Re: Addendum Number 5
IFB # C1592 – Goodman Lower Level Gallery New HVAC Unit

FIT GOODMAN LOWER GALLERY NEW HVAC EQUIPMENT
282 7TH AVENUE, NEW YORK, NY 10001

SK-FA001

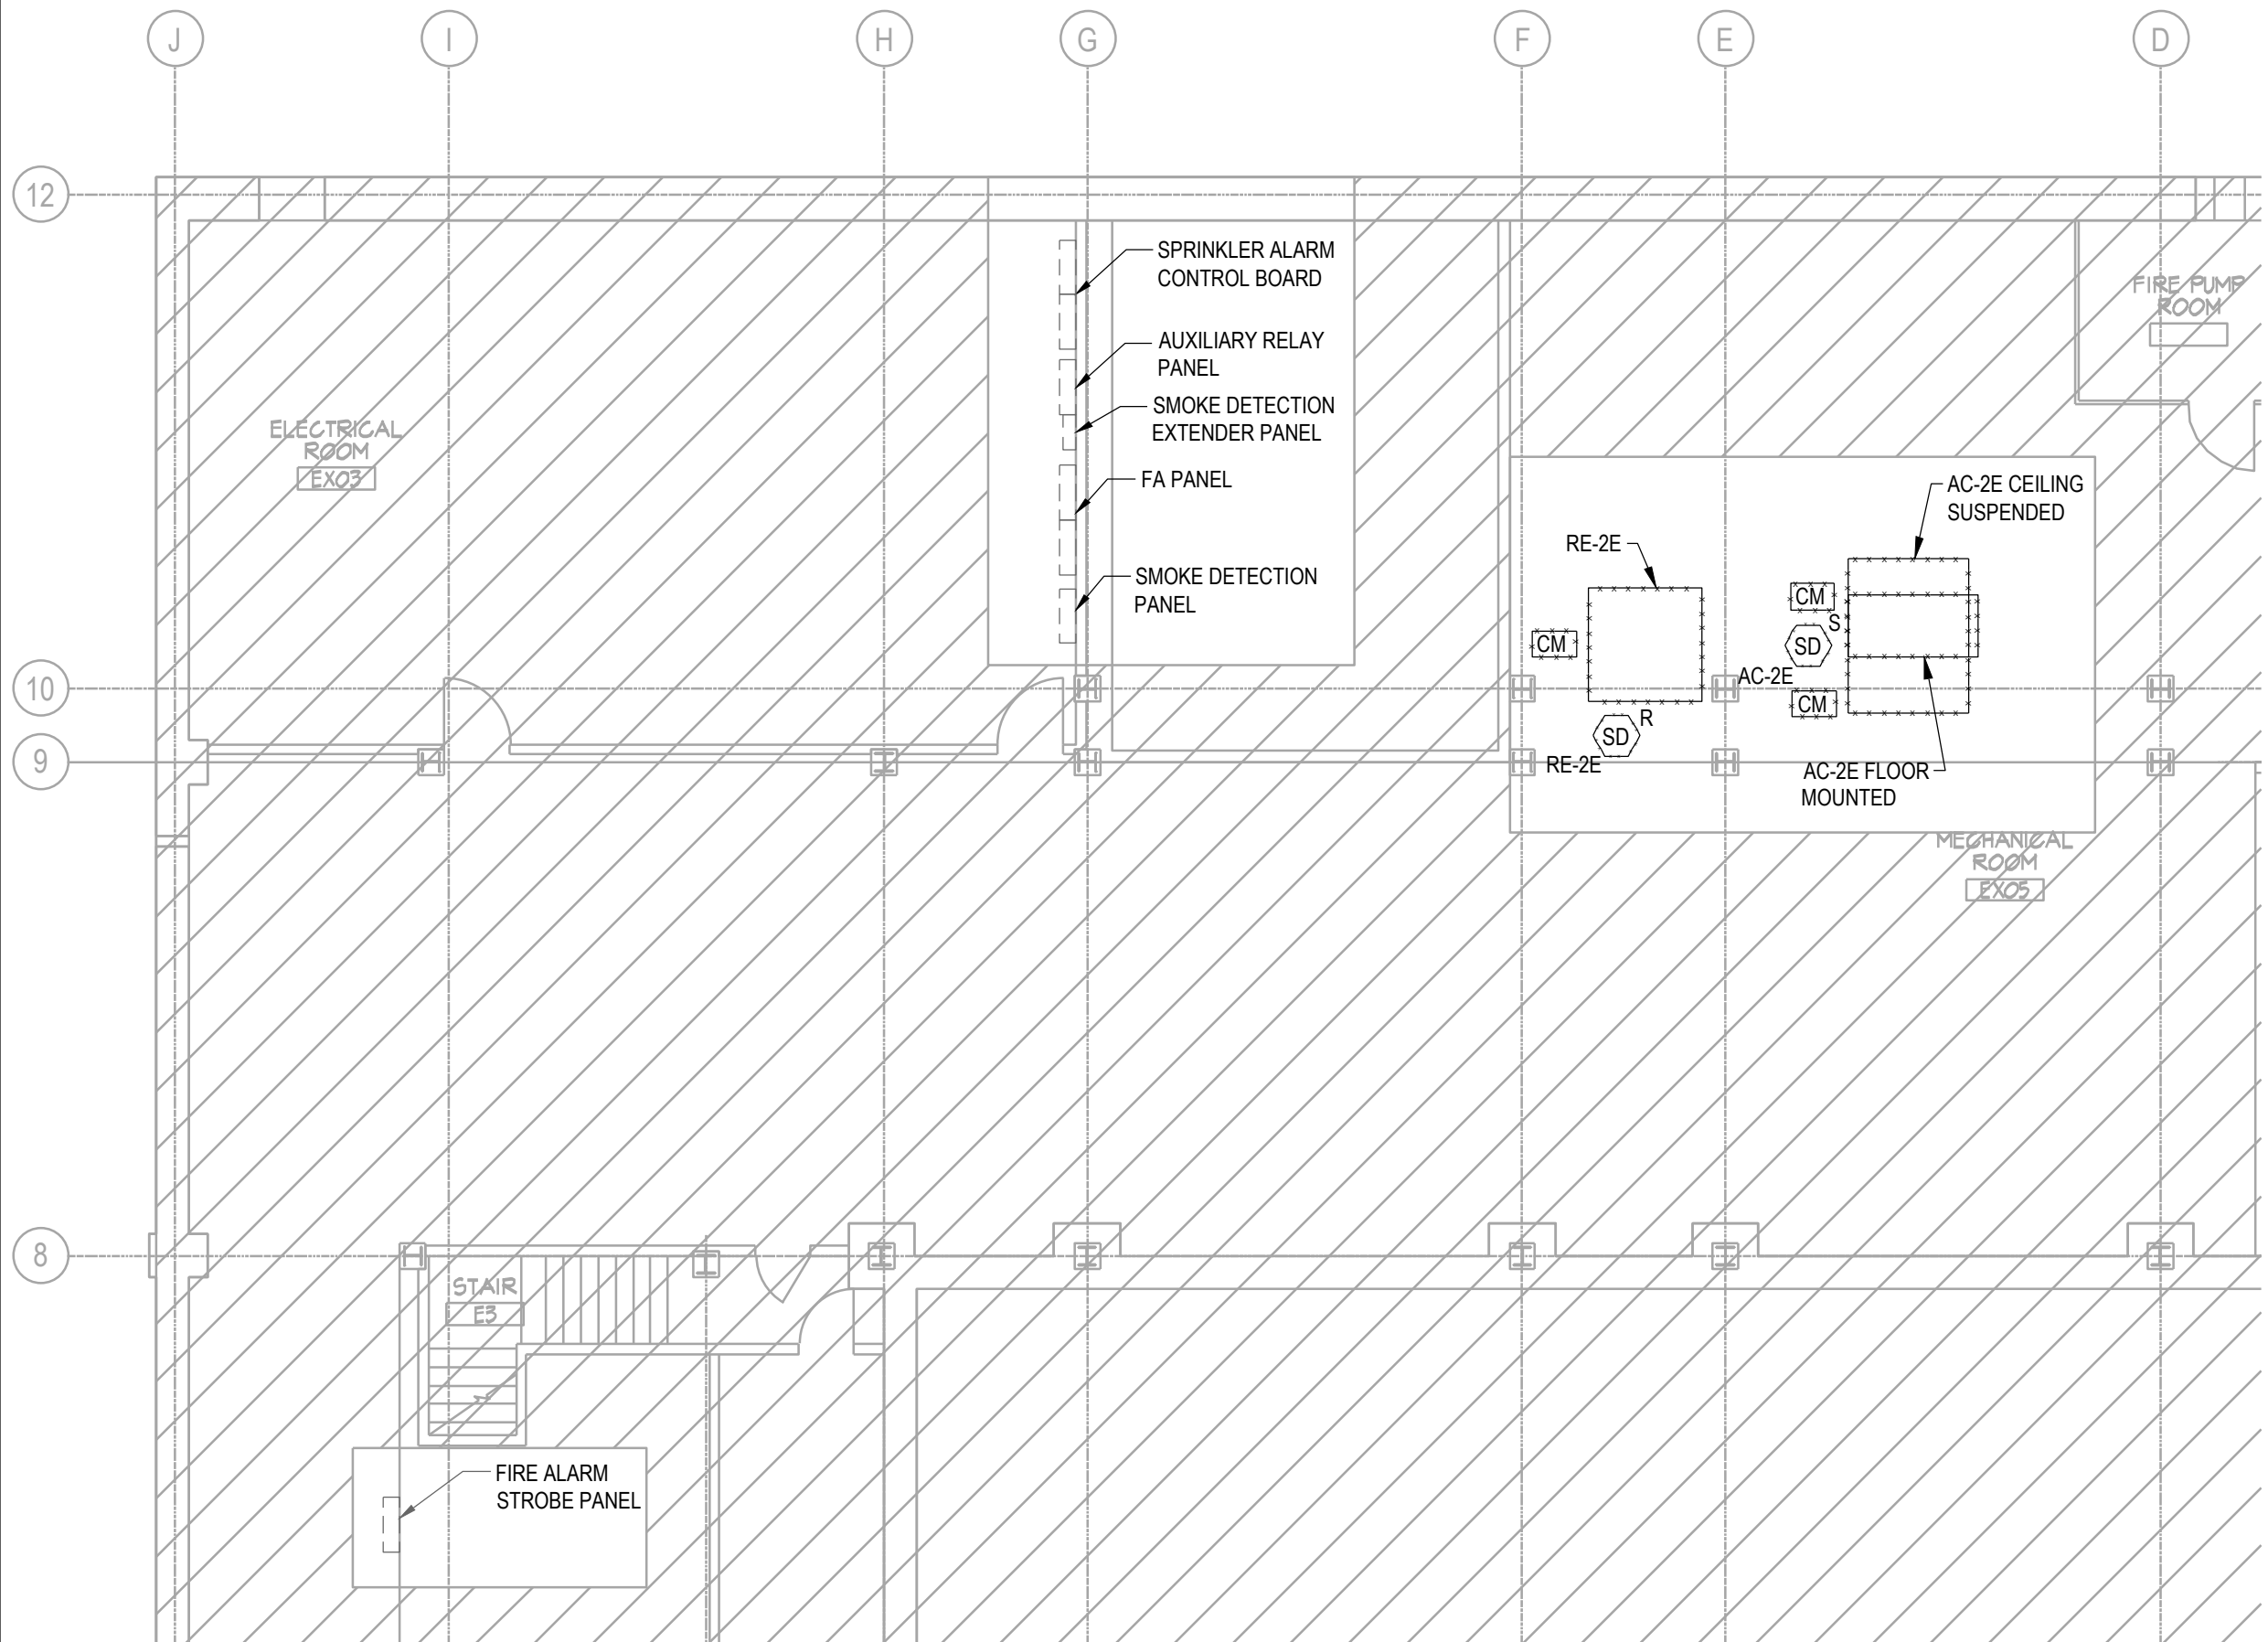
Revision: RISER DIAGRAM ADDED TO COVER PAGE

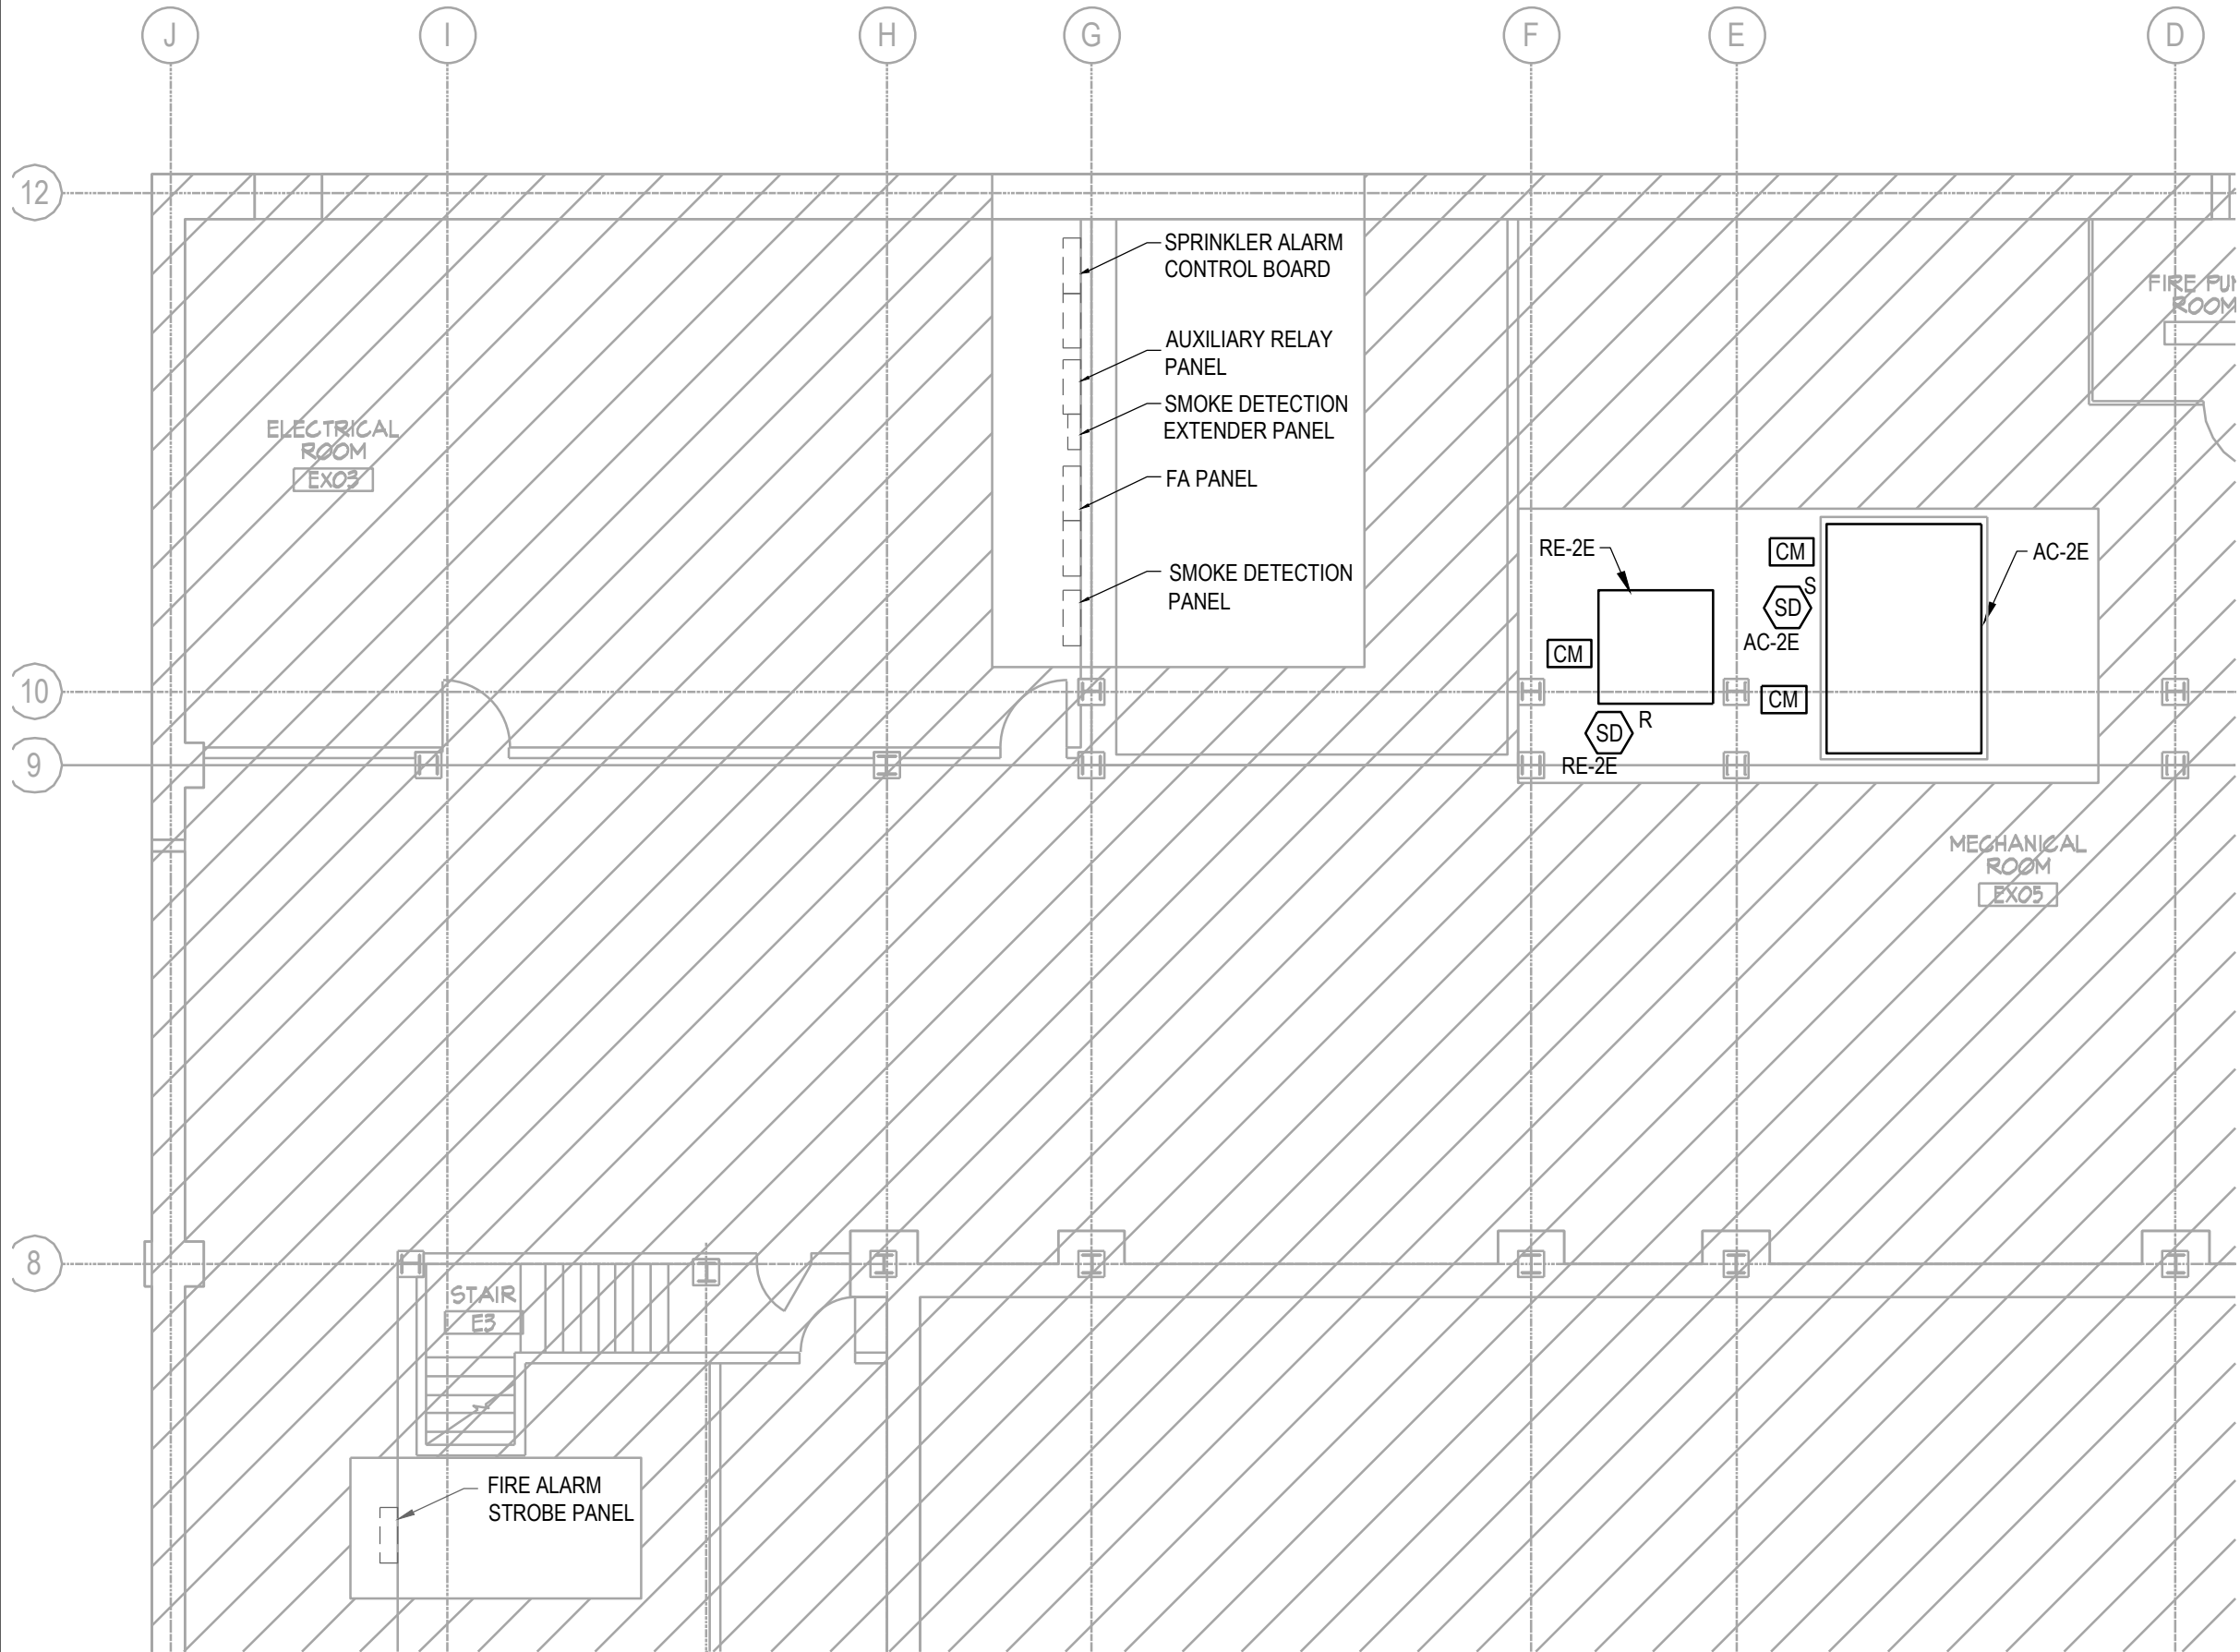
1. EXISTING DUCT SMOKE DETECTORS AND CONTROL MODULES ASSOCIATED WITH FAN SHUTDOWN TO BE REMOVED. ASSOCIATED CONDUIT AND WIRING SHALL BE REMOVED BACK TO THE SOURCE.

SK-M503

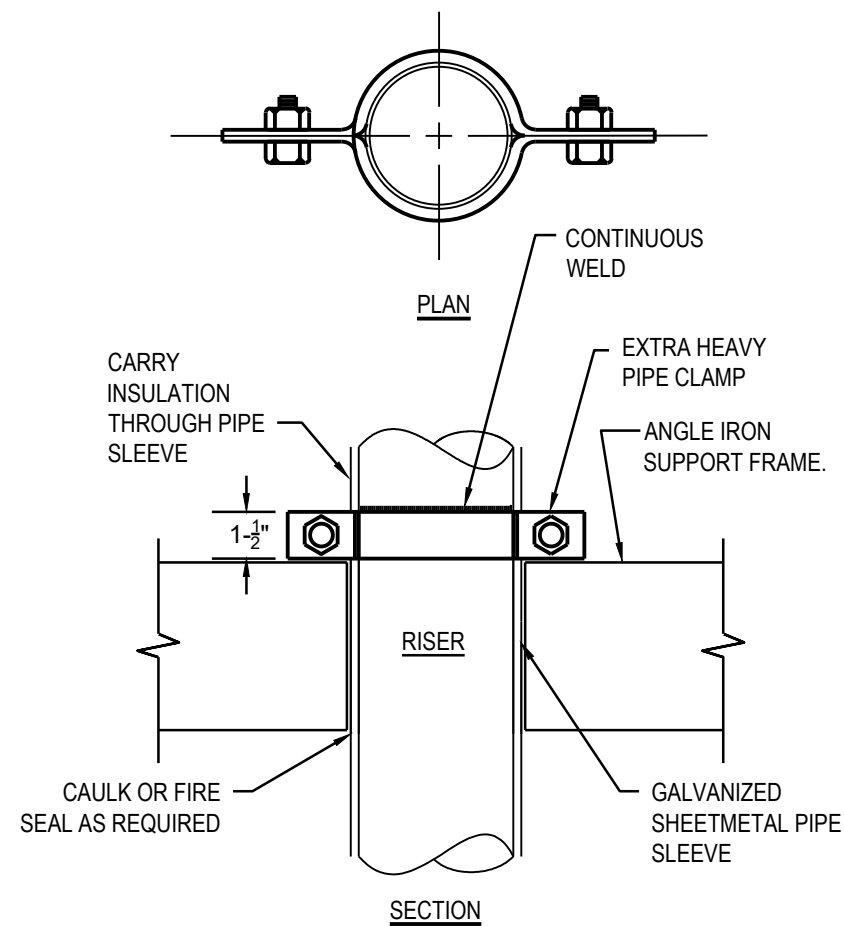
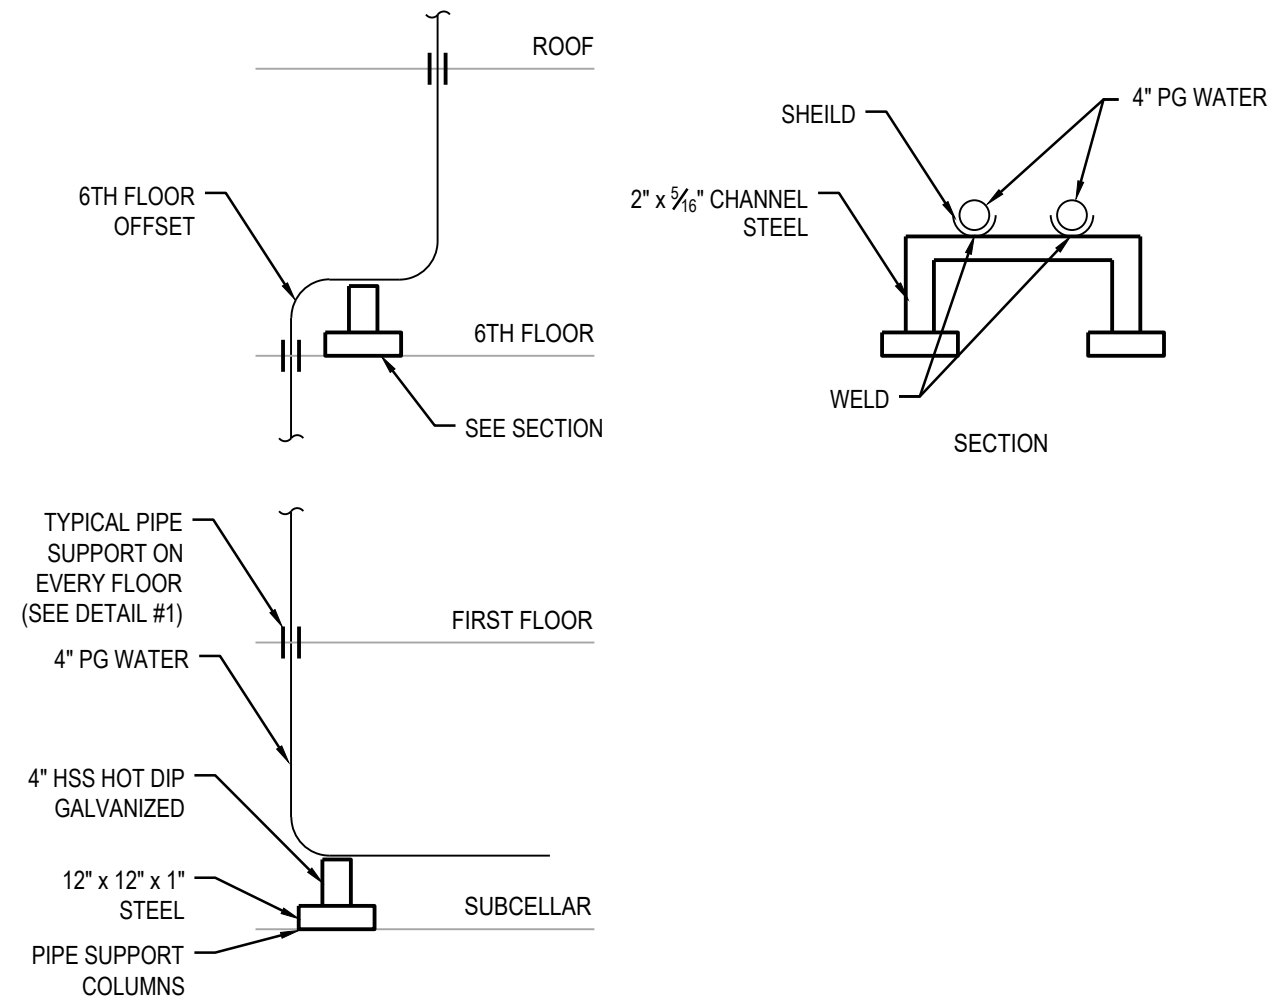
- A1. A line for miscellaneous items has been added to the updated bid analysis form. See attached.
- Q2. Drawings M600 shows “pipe support columns” at the base of the risers. Please provide a detail of these support columns.

- A2. See sketches provided for pipe supports.
- Q3. M503 and M504 show details for pipe anchors and guides. Please show where these are applicable, including quantities, on the drawings.

- A3. Anchors are not required. See sketches provided for pipe supports.
- Q4. Drawings M401 calls for the relocation of existing reheat piping as needed to allow for installation of the new risers. Please indicate on the drawings what piping is in conflict and would need to be removed or include an allowance in the contract for these relocations.

Pipe Support Detail Typ. Each Floor

Pipe Support Details

Revision: PIPE SUPPORTS
